© 2015 Mazda Motor of America, Inc.

Subject: REAR CONSOLE LID IS LOOSE	Bulletin No: 09-023/15
	Last Issued: 12/14/2015

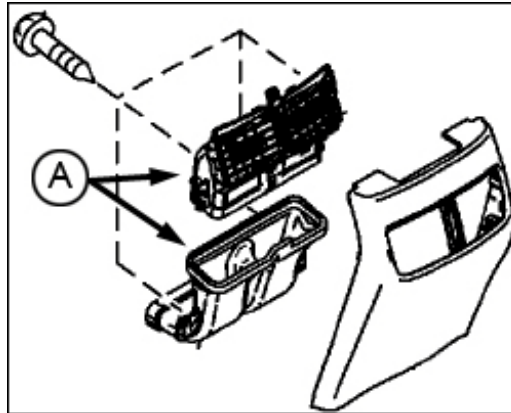
4. **Mazda3 and Mazda6 without ventilation**, install a new rear console panel. (See PART(S) INFORMATION)

NOTE: The shape of the rear console panel has been changed, by adding a stopper rib to prevent the pin from coming off.

Rear Console Panel with Ventilation Repair Information

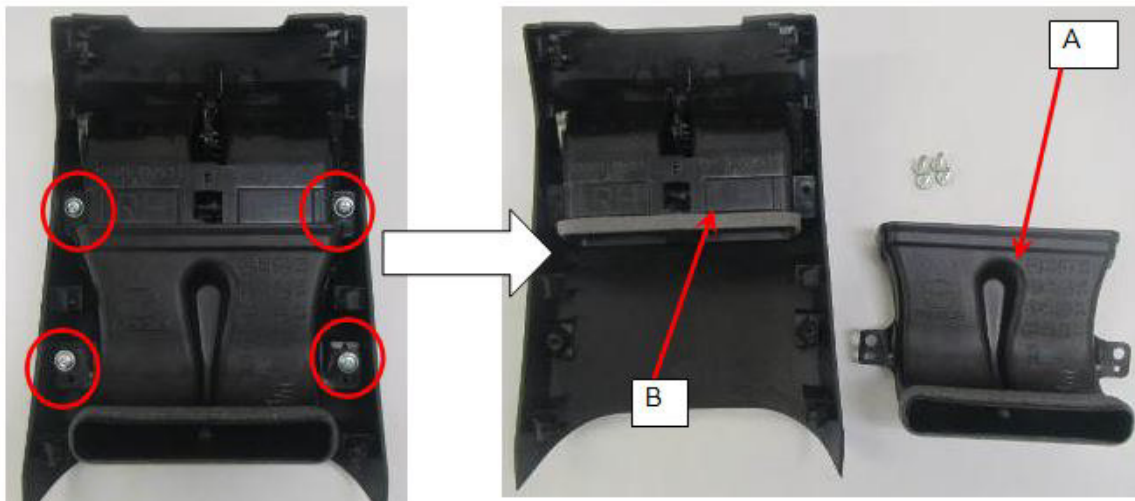
5. Mazda6 with ventilation, install a new rear console panel (see PART(S) INFORMATION) and reuse the rear and front ducts (A).

NOTE: The shape of the rear console panel has been changed, by adding a stopper rib to prevent the pin from coming off.
